**SITE PLAN REVIEW SHEET
ENVIRONMENTAL VARIANCE REQUEST ONLY**

CASE: SP-2013-0077D

PROJECT NAME: IH-35 Frontage Drive Access to AISD SE Bus Maintenance and Service Facility

PROJECT: AUSTIN SOUTHEAST BUS MAINTENANCE & SERVICE FACILITY
 CLIENT: AUSTIN ISD
 DATE: 10/15/2013
 DRAWING: SITE PLAN - CONSTRUCTION AND GRADING PRELIMINARY - CUT/FILL

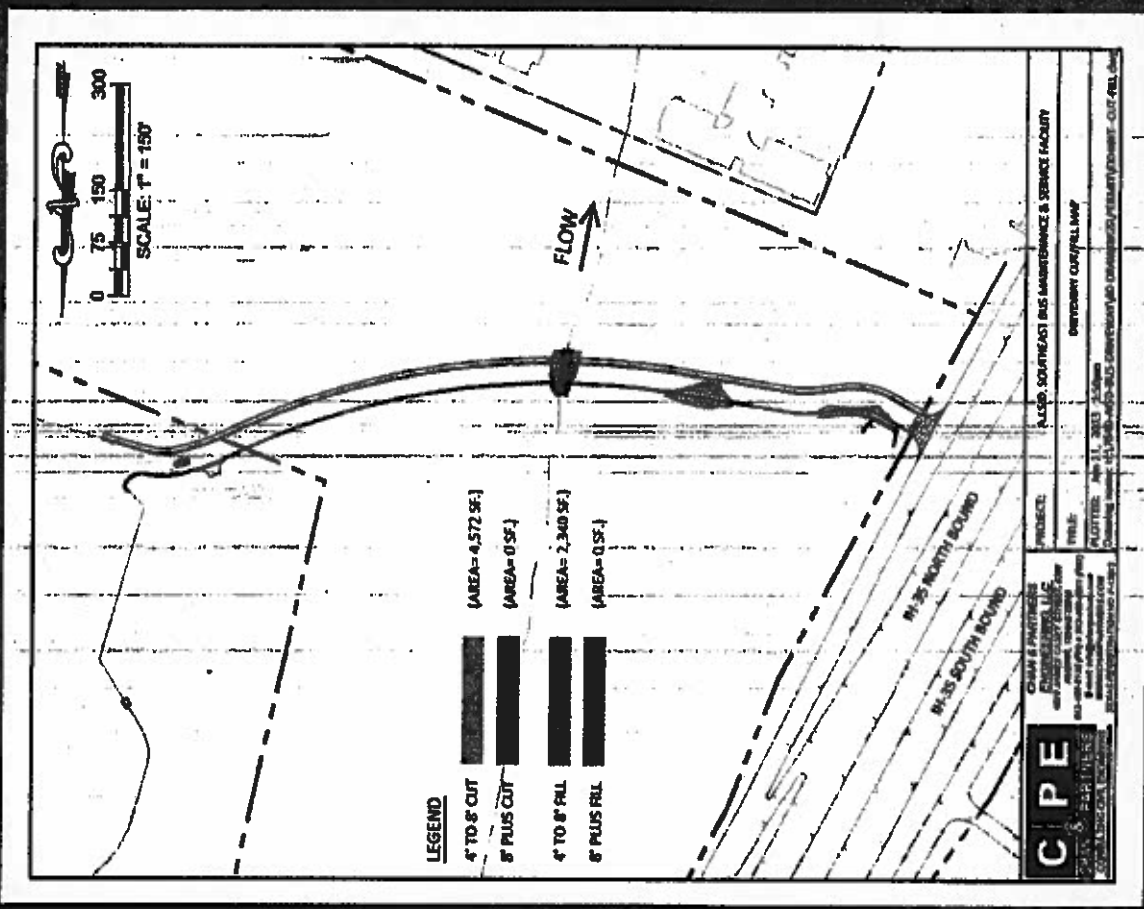
Construction of the driveway requires cut and fill between four and eight feet (Sections 25-8-341 & 342) in areas where the existing ground slopes exceed 15%. As such, this cannot be an administrative variance. In addition, a driveway may not be constructed on land slope greater than 15% unless it provides primary access (Section 25-8-301). As the adjacent land use site plan has not been processed, it cannot be confirmed at this time that this drive will provide primary access.
